City of Portland Design Commission

Design Advice Request

SUMMARY MEMO

Date: December 10, 2021
To: Gary Golla, SERA Design and Architecture Inc.
From: Benjamin Nielsen, Design / Historic Review Team, BDS
(503) 865-6519, benjamin.nielsen@portlandoregon.gov
Re: EA 21-082922 DA – Choice Cambria Hotel
Design Advice Request Commission Summary Memo – October 21, 2021

EAST ELEVATION - PARK AVE. C26

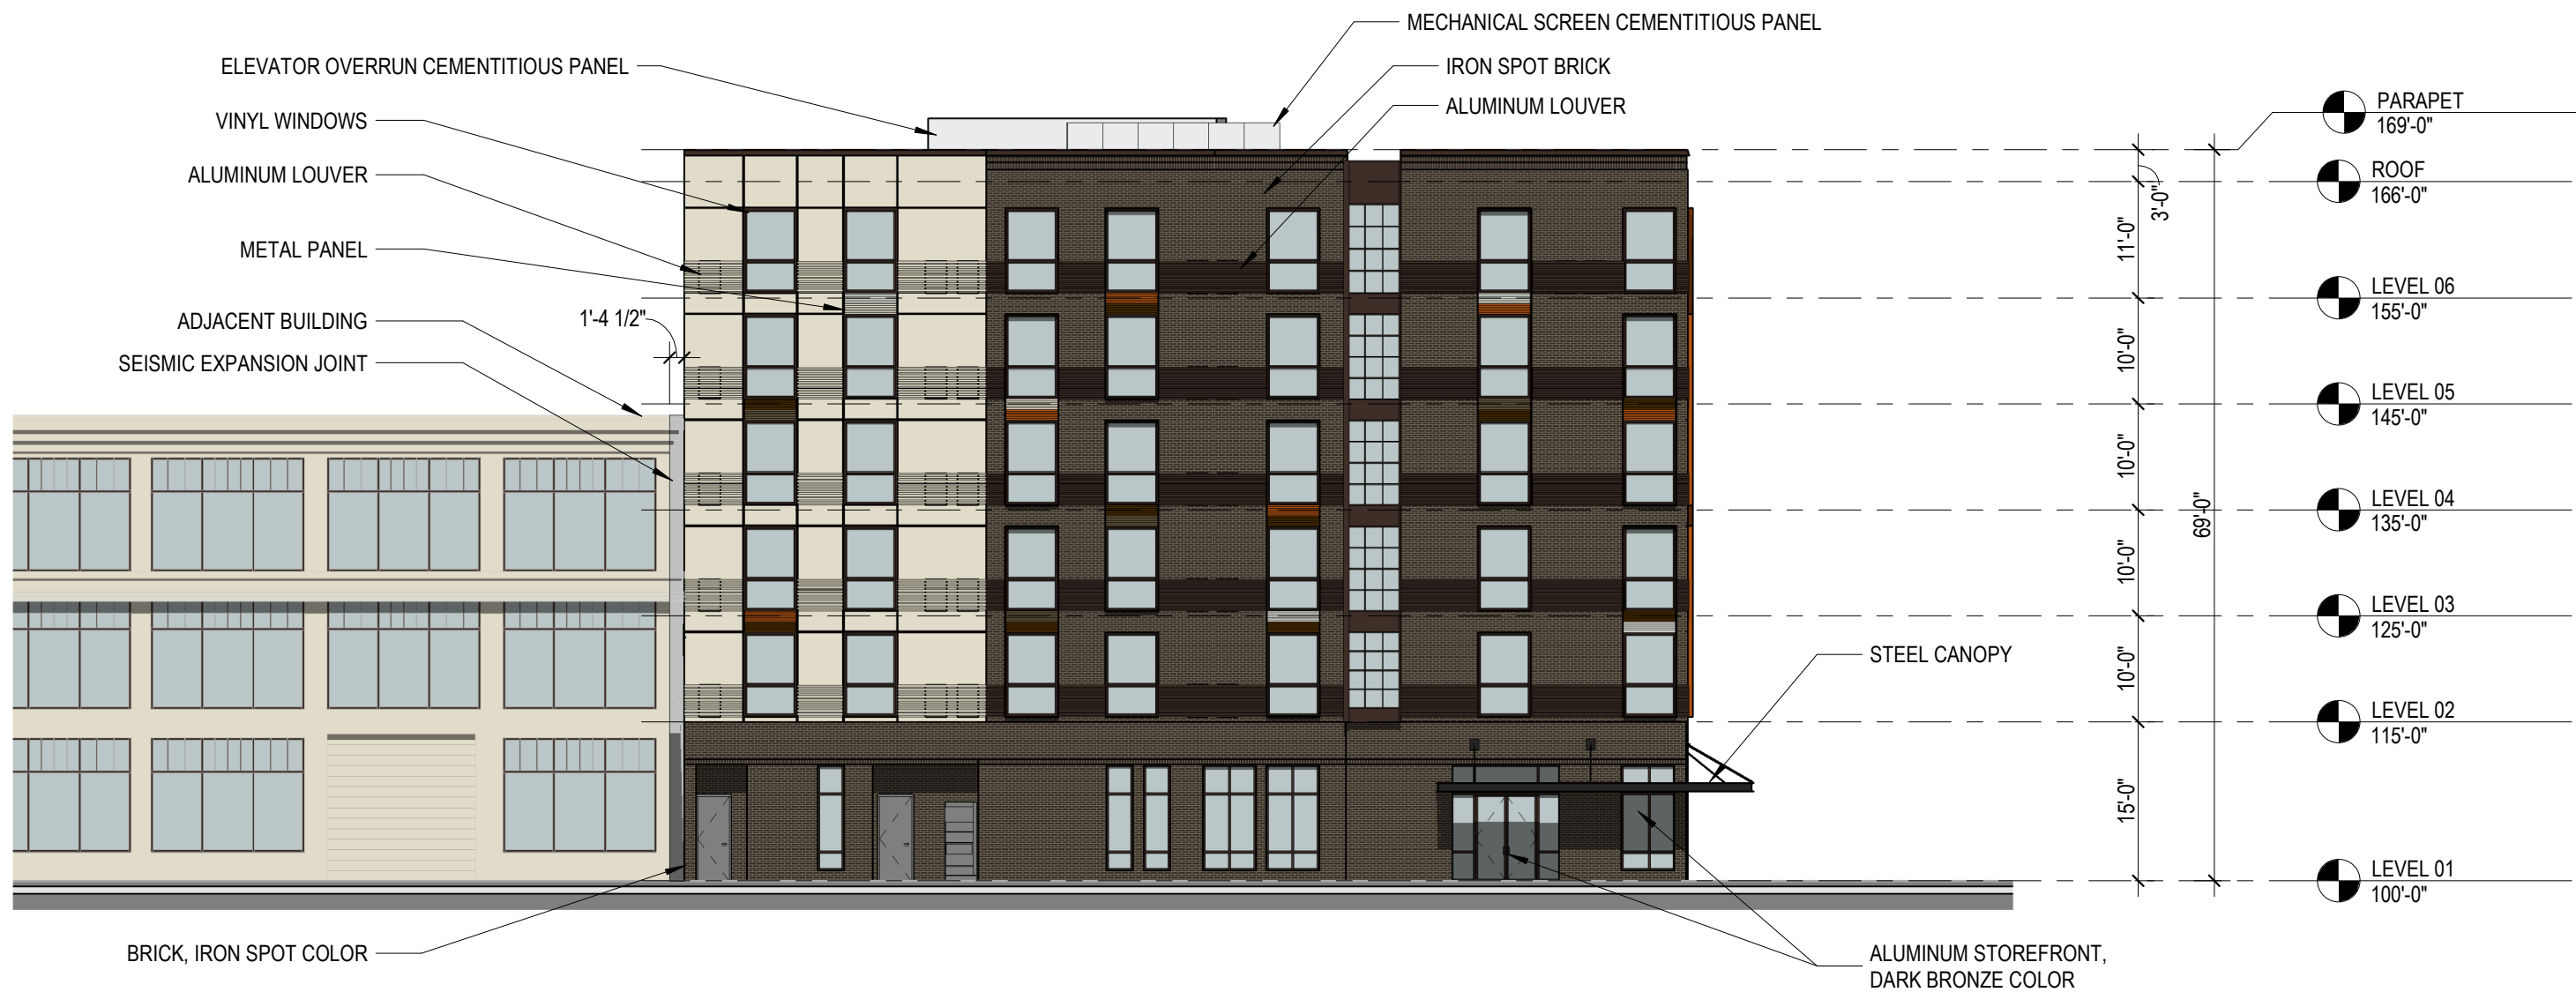
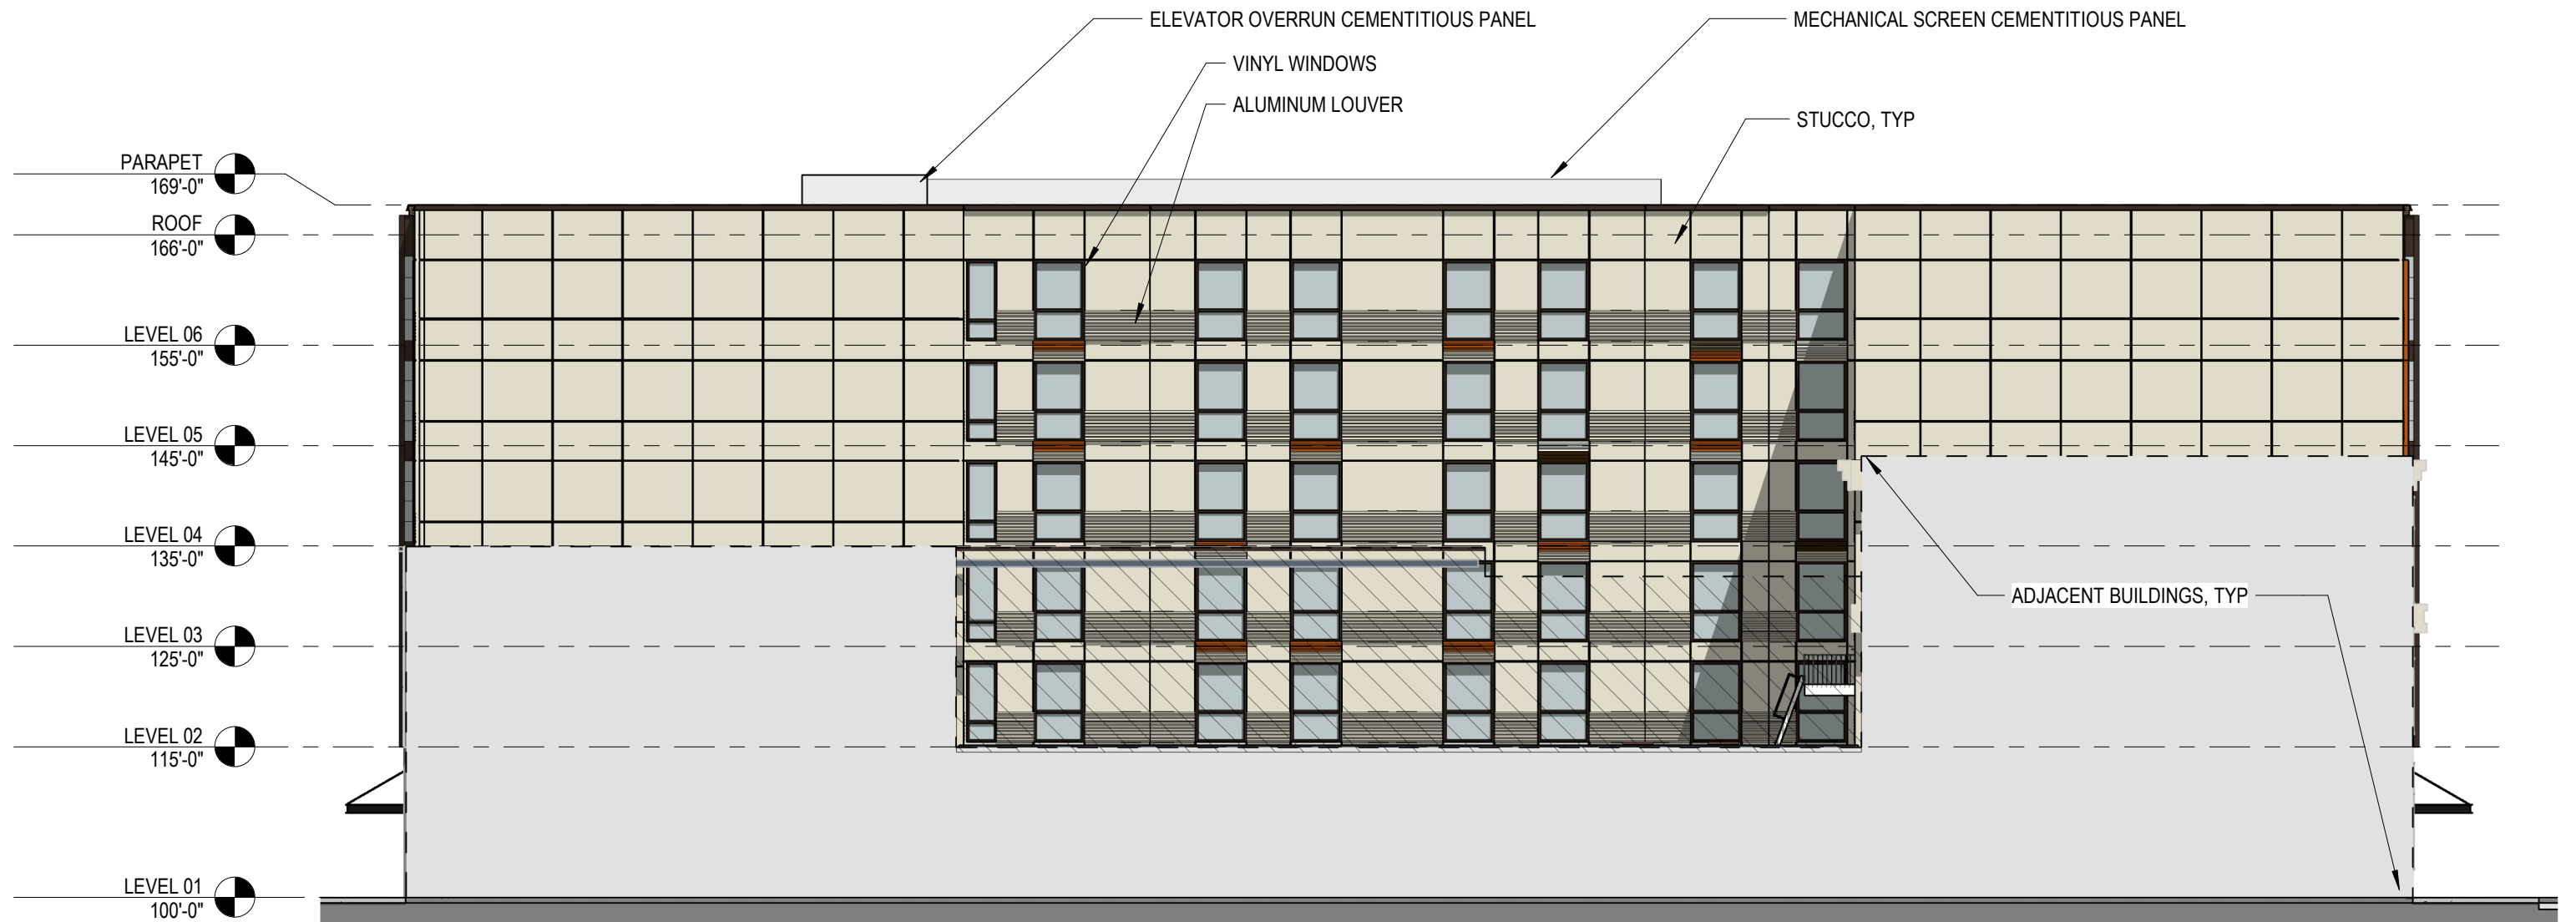
2. Commissioners agreed that the proposal needs further simplification in its massing, a reduction in the number of different materials used, and more attention to critical details. One commissioner said the building should be something solid and “a simple reflection of the Park Blocks”.

- a. Most commissioners believed that the materiality of the design lacked coherency, with one noting that the “fussiness” of the various materials threw off the coherency of the massing. Commissioners said that the number and type of materials should be reduced. Another commissioner suggested that one material—preferably brick—would be best for this area.

- b. Commenting on the orange accents proposed around the windows, one commissioner said that would likely appear dated, and that the color palette should be desaturated for the Park Blocks context.

- c. Each commissioner touched on window patterning, and though each had a differing viewpoint on the details, all agreed that it was important to ensure that the patterning of the windows is regular and does not complicate the design.

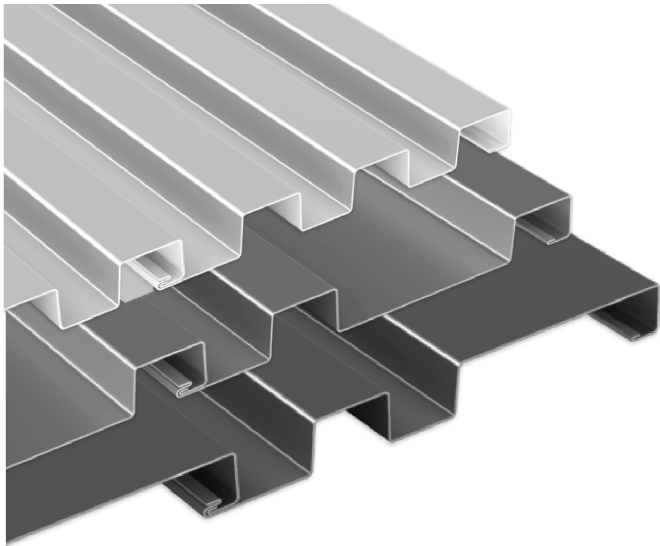
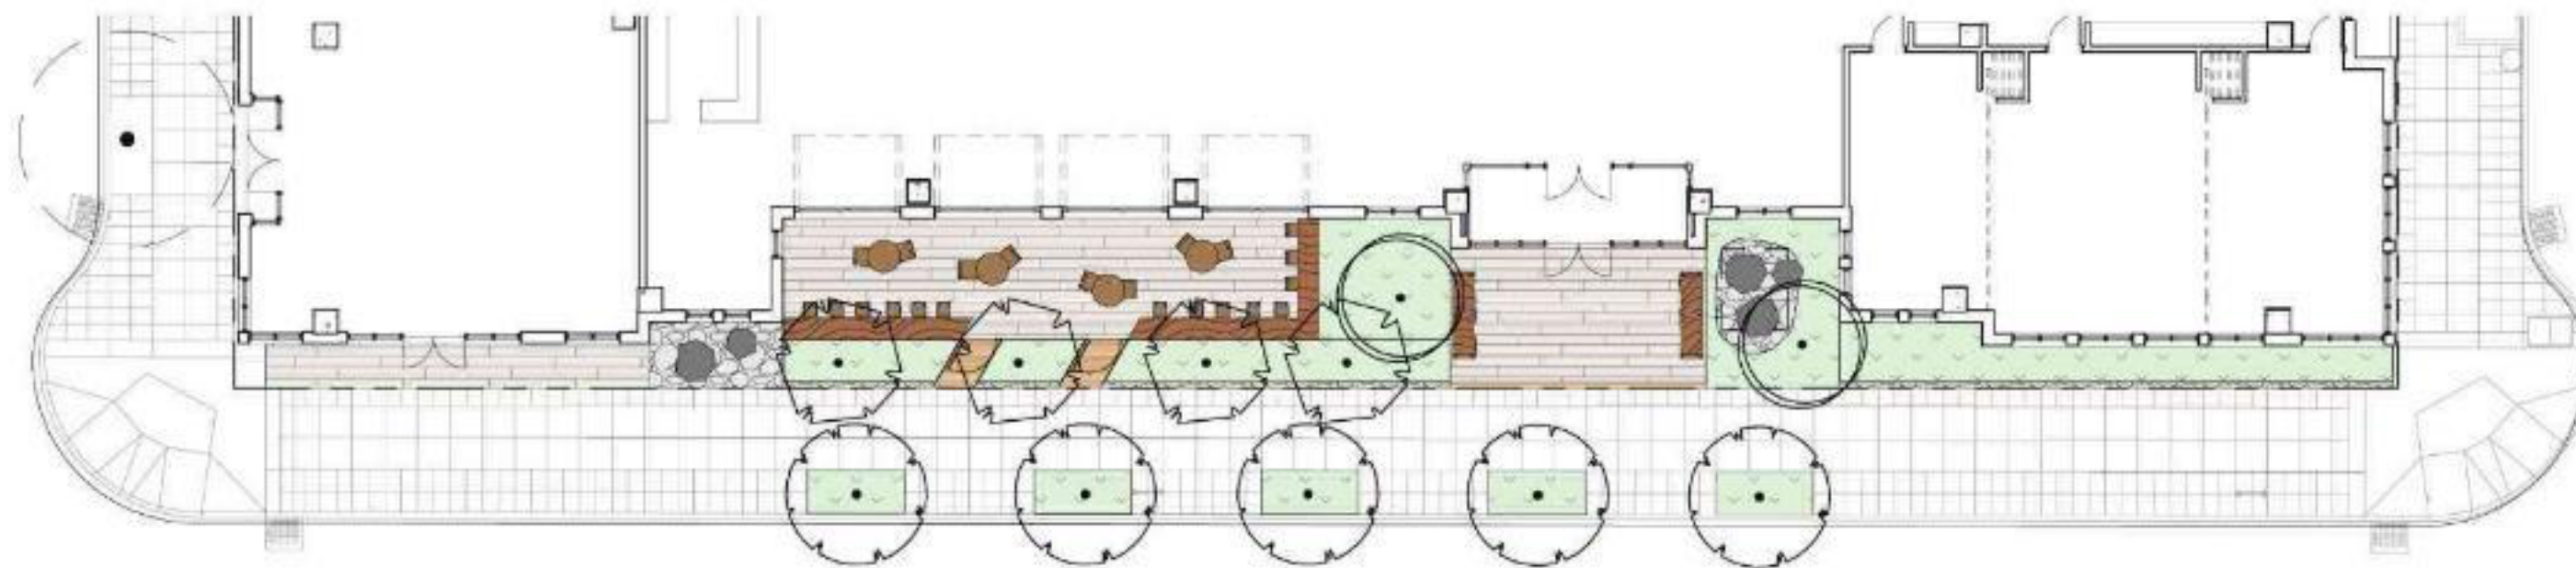
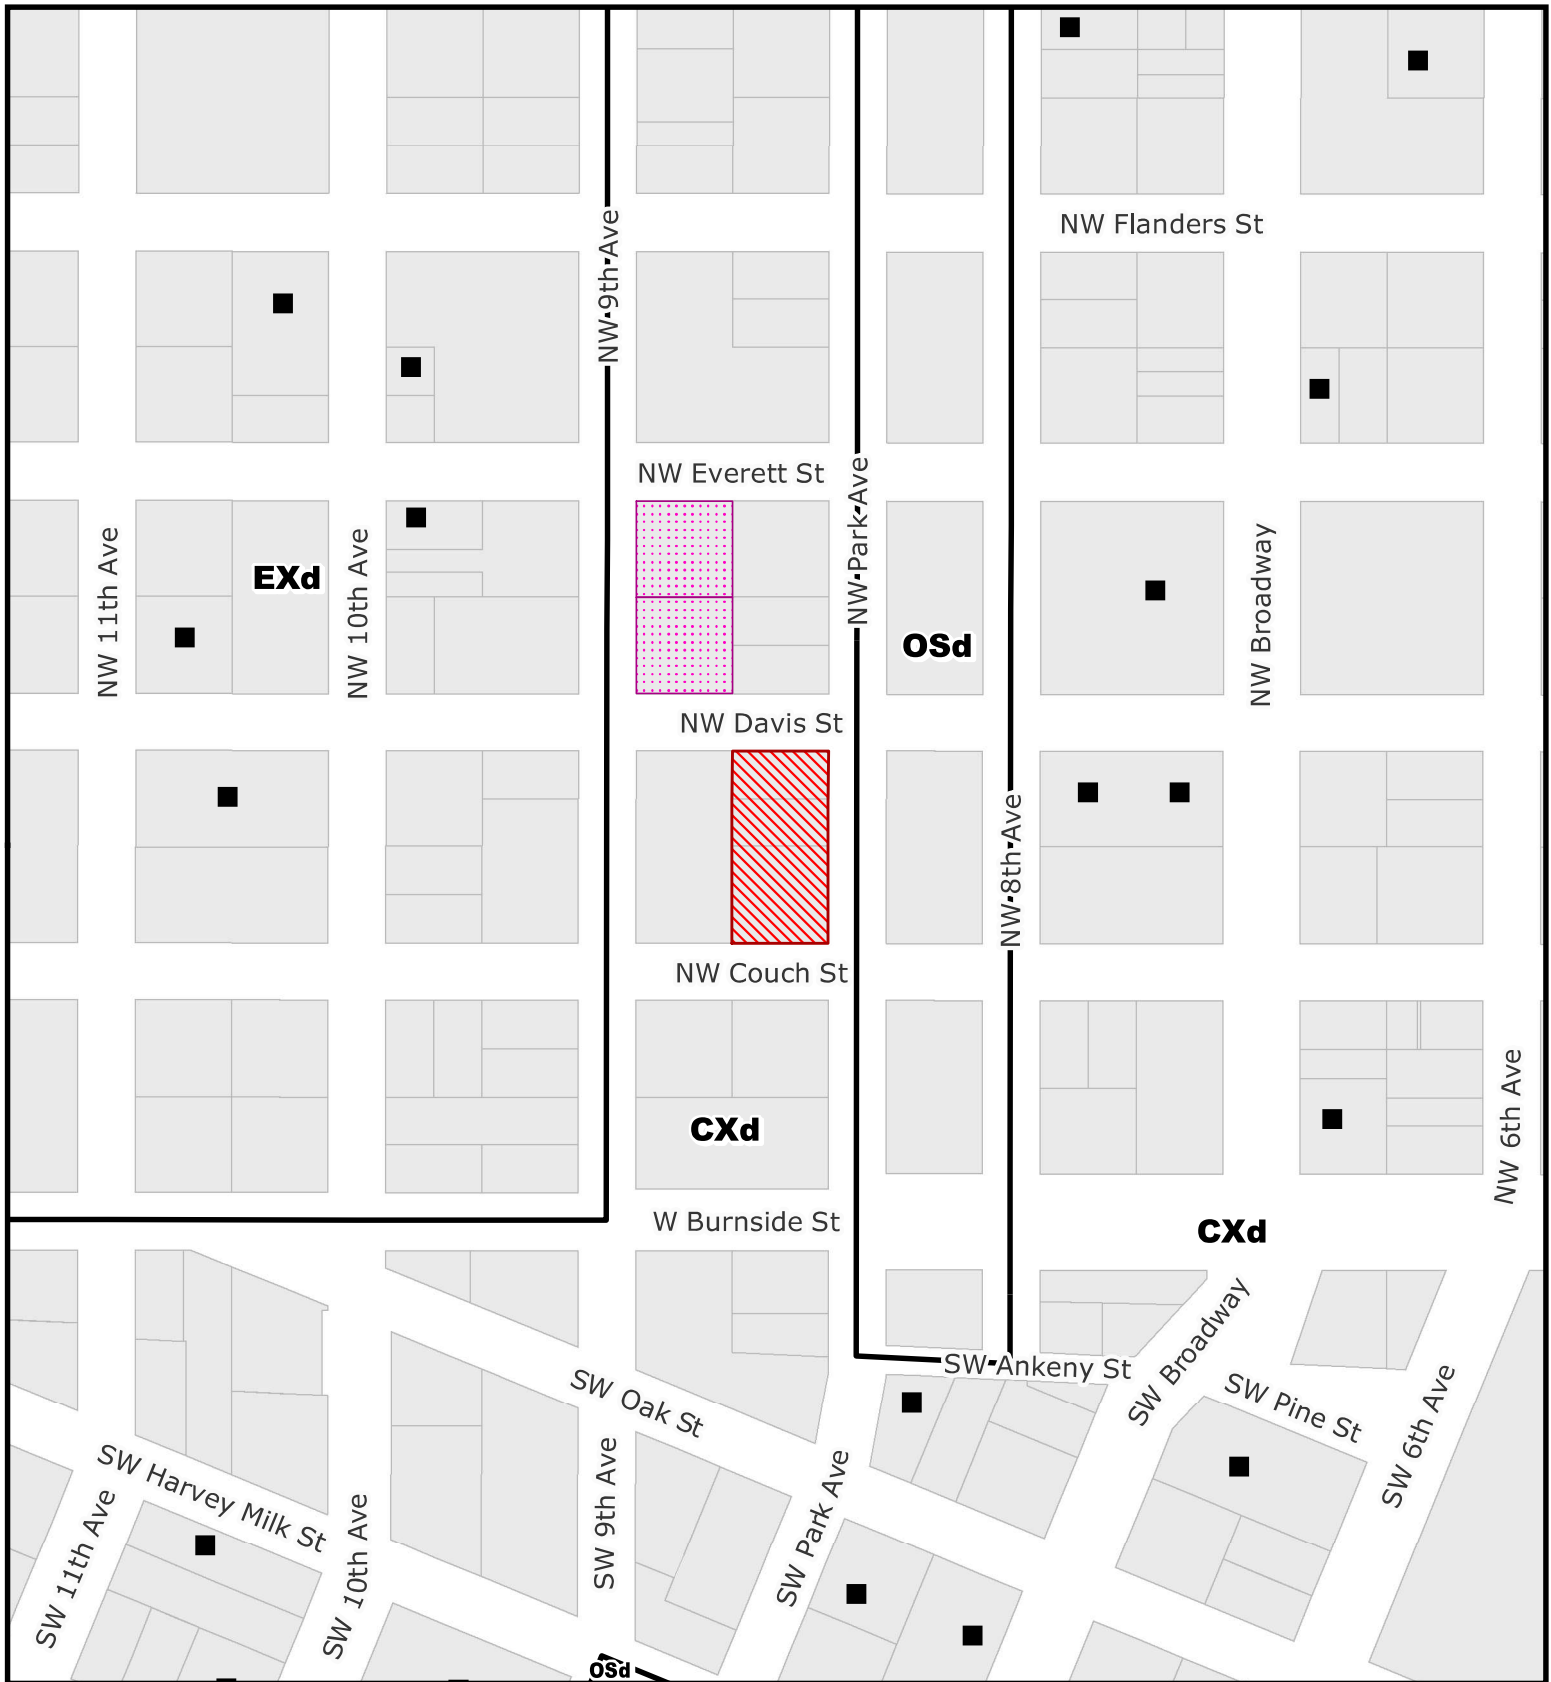
- d. Regarding stucco, most commissioners thought it was not a good material choice for the Park Blocks context, citing the likely growth of mildew.
- e. The Commission agreed that the louvers detracted from the overall coherency of the building (as well as not being compatible with the North Park Blocks context).

1. **Exterior materials.** Brick, stucco, ribbed metal panels, and aluminum louvers are the primary cladding materials (see sheet C29 for material list). Metal fins (likely brake metal) and dark bronze vinyl windows comprise the typical window system on the upper floors.

Setback & massing

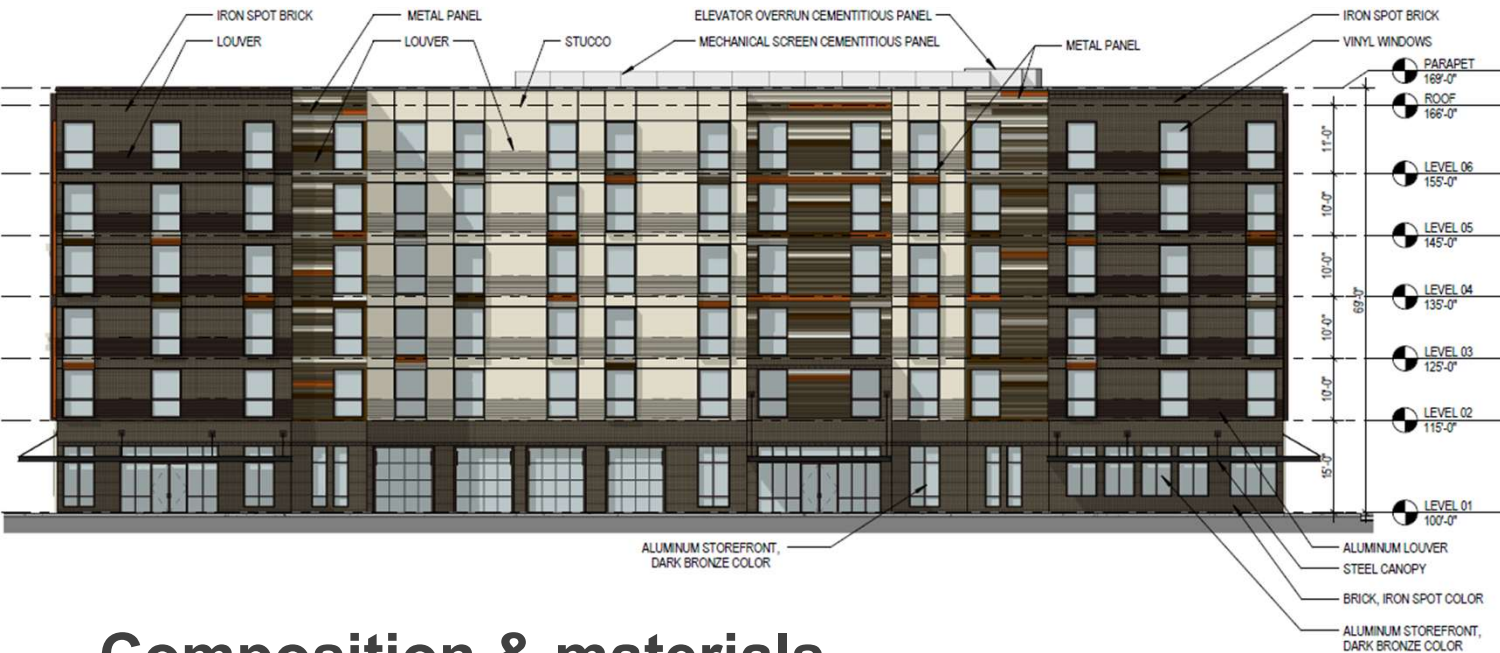
The building incorporates a setback/courtyard roughly in the middle of the east façade facing the North Park Blocks, taking a more-contextual approach towards addressing the Green Loop-related Required Building Lines standard. The building's massing could respond better by fully extending the north and south wings to the property line along the sidewalk edge, rather than setting these wings back by approximately 4 feet.

The composition of the east façade incorporates a wide variety of materials, including brick, stucco, and metal panel, on the varying planes of the east elevation. Existing buildings facing the North Park Blocks, whether historic or contemporary in character, tend to incorporate a more unified palette of materials. In order to better complement the context of development facing the North Park Blocks, a cladding concept with one primary material plus one or two accent materials should be used.

Setback/courtyard

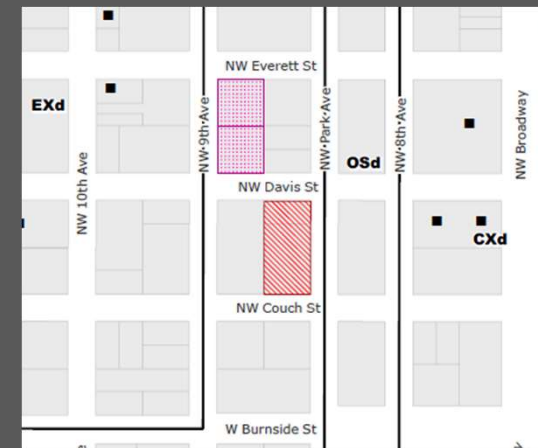
Proposed planters appear to be composed of weathering steel and raised above sidewalk grade, creating a visual barrier between the sidewalk and the patio and interior of the restaurant/bar area (see sheets C10 and C31). An at-grade planter, or possibly one with a lower height, would allow for better visual connections. A low fence may help to provide additional barrier/buffer, if needed.
